工程指示 / 要求簡箋(E.I.)

工程指示編號：EI / 1497 / 20

工程名稱：觀塘裕民坊

工程項目：特式層 窗門 access panel 拆圖資料 (包 insitu 及 facade 窗)

30A-LV-2  
 SECTION  
 1 NOS.  
 TO 50/F FLAT A CIV  
 WITH THE CLEAR TEMPERED GLASS

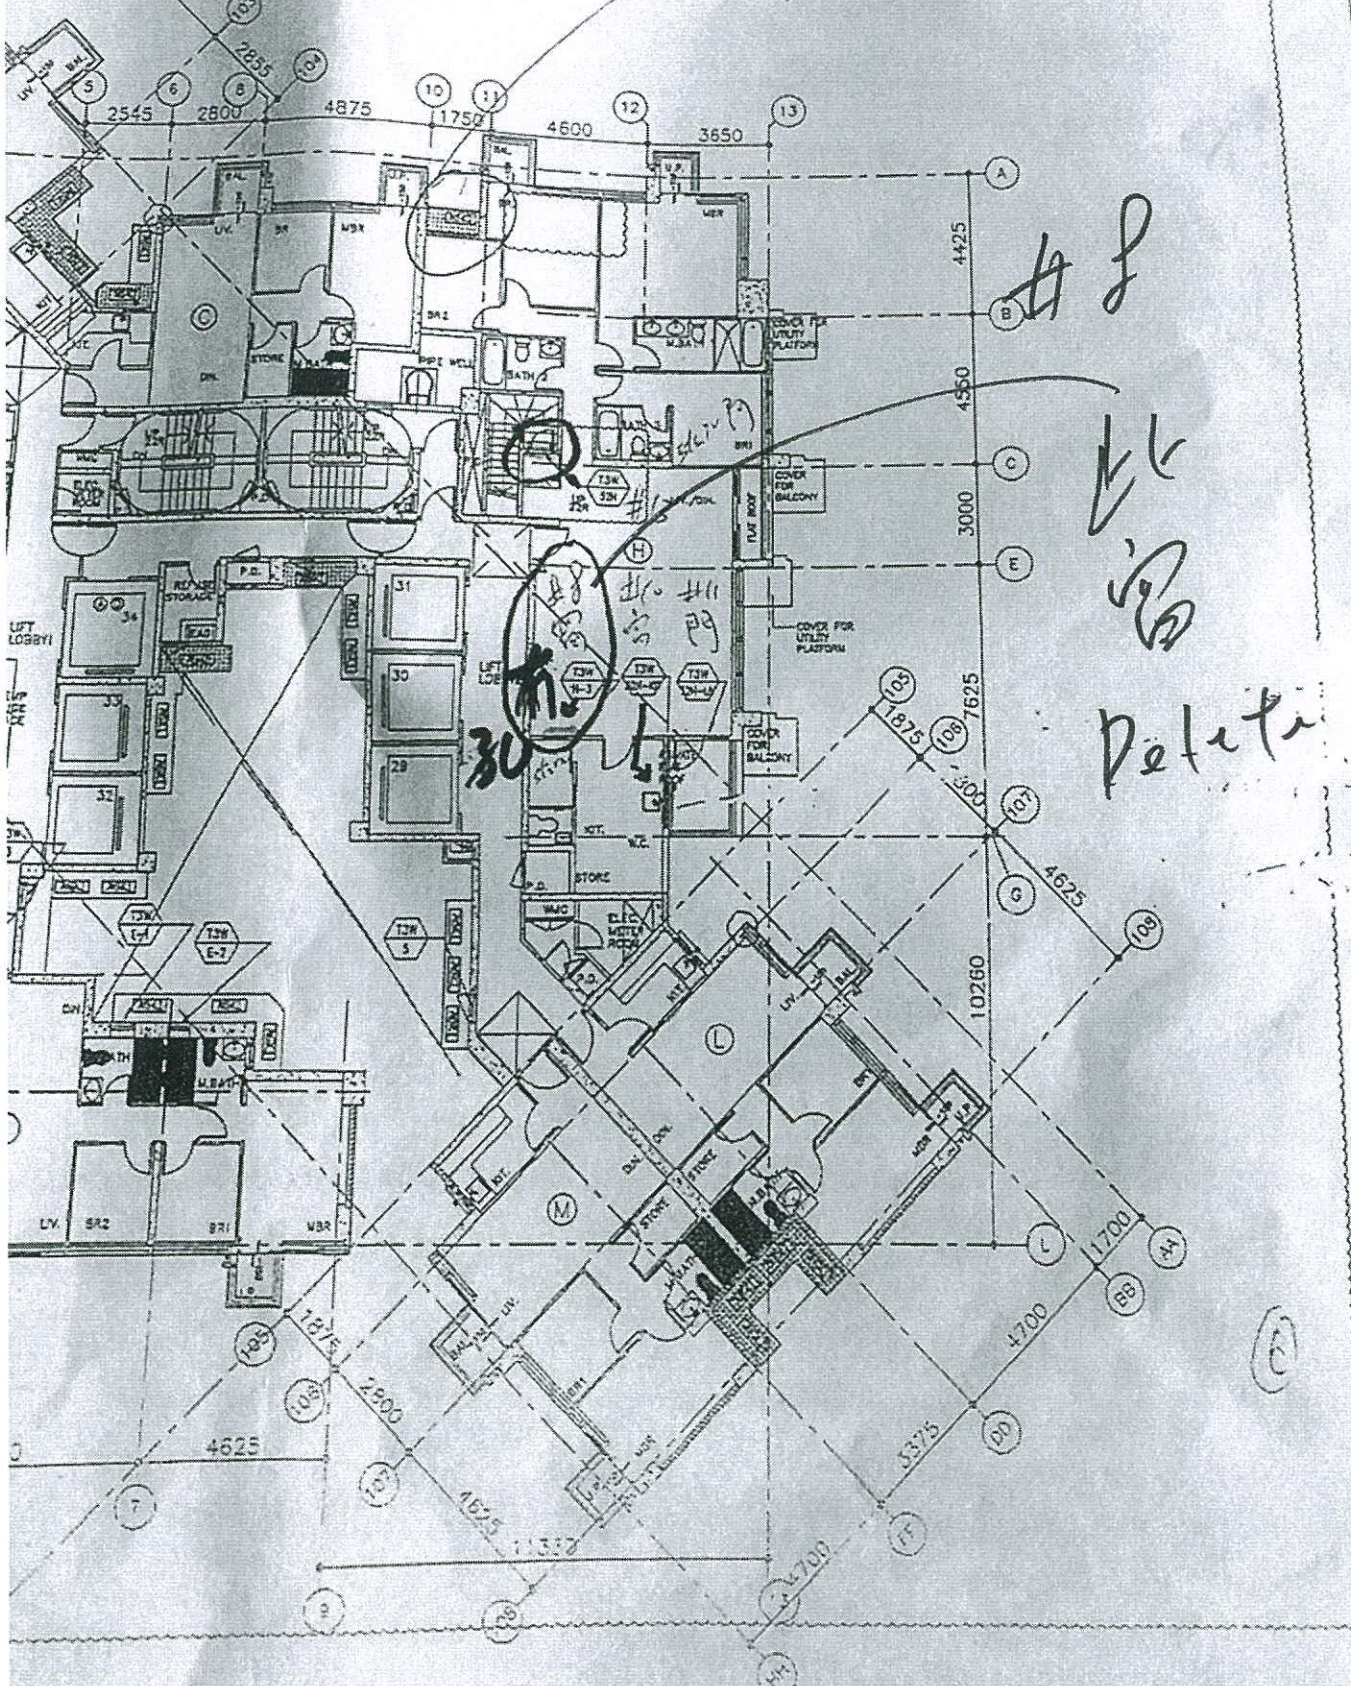
D-D 相差多少?

#4

按圖繪

T3 - 52/F FLOOR PLAN

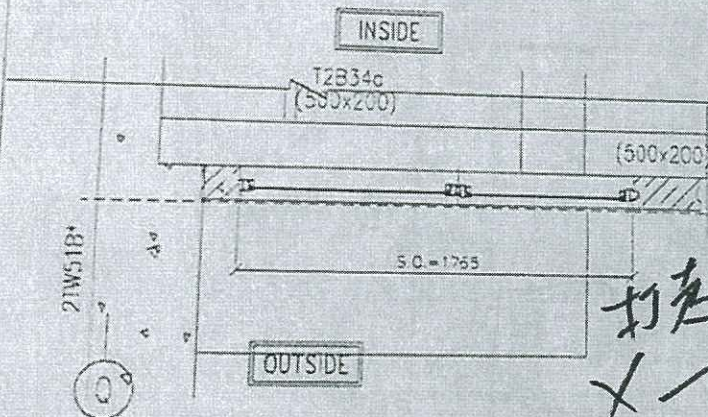
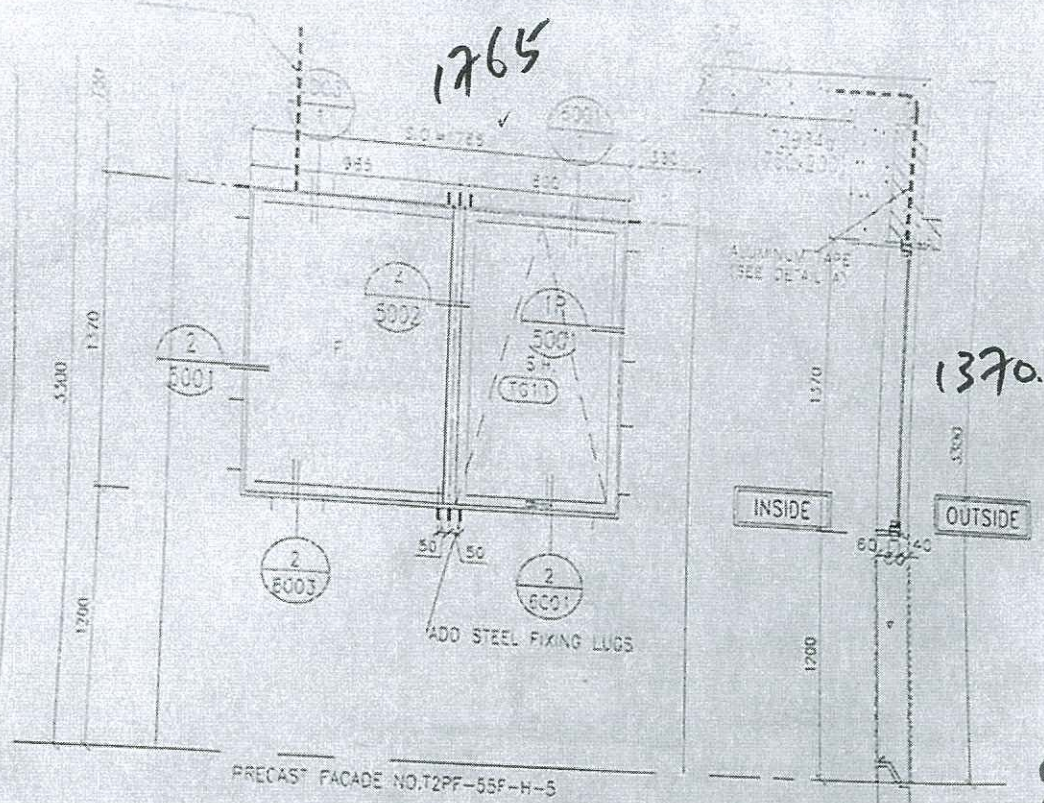
現場尺寸

1250 x 1370

WINDOW MARK		700 700 700	
SECTION	50mm ALUM. SECTION	现场佛沙窗	50mm ALU
QTY.	1 NOS.		1 NOS (S)
LOCATION	T2 55/F FLAT G 9R3		55/F CO
GLAZING	8mm THK CLEAR TEMPERED GLASS		8mm THK
EMER.			OPENABLE

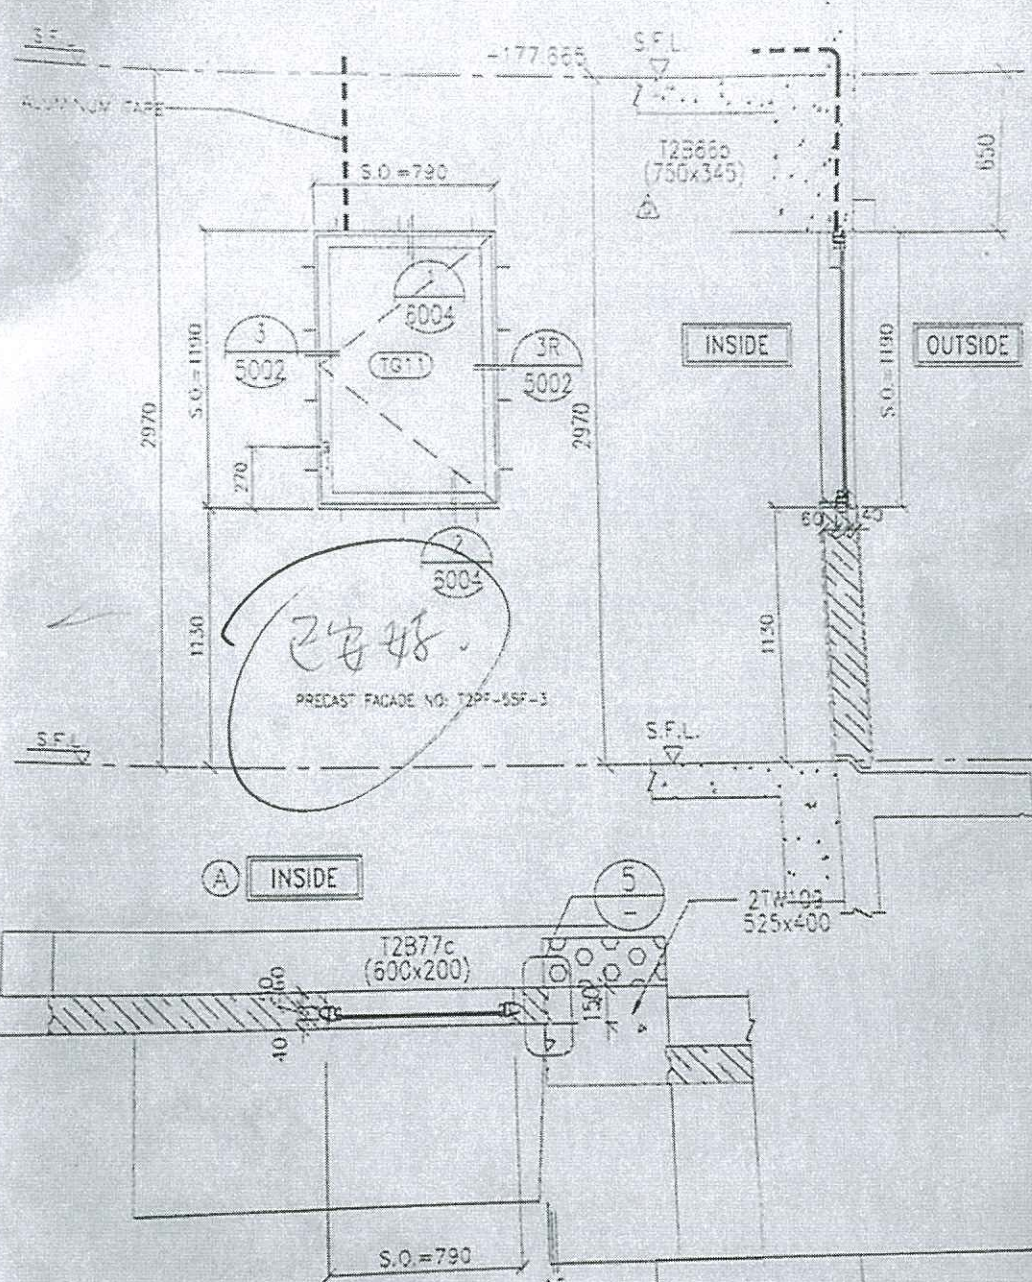
打走佛沙窗 2改  
GBP.

NEW S.O.	1765(W)*1370(H)
ORIG S.O.	1725(W)*1330(H)

?  
Please also follow up the revised opening for two pieces of precast fa鏗de per coordination with CR and MVAC NSC on 12/06/2019 at RFI meeting regarding the required space for pipes works:-

- 1. 牋牋牋 T2 55/F Flat G BR 3
- 2. 牋牋牋 T3 52/F Flat H BR2, please note further to Midi report on the openable calculation- the top hung window shall be 780(W) X 1330(H) and the remaining shall be fixed glass.

現場打佛沙窗  
按圖做新窗

則即 13/6 電郵  
 確認 780 x 1330  
 + 樓頂 玻璃
